LAKE KALMIA DAM

NJ 00166

PHASE 1 INSPECTION REPORT
NATIONAL DAM SAFETY PROGRAM

REPT. NO: DAEN/NAP-53842/NJ00166-81/08

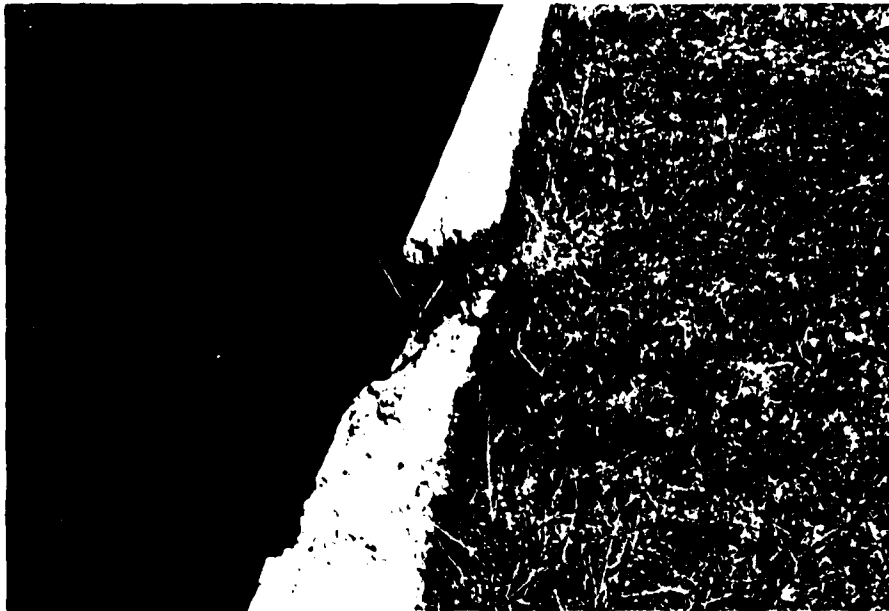
Saddle about 400 feet east of dam that probably would serve as emergency spillway. Looking at upstream face from west side of bay.
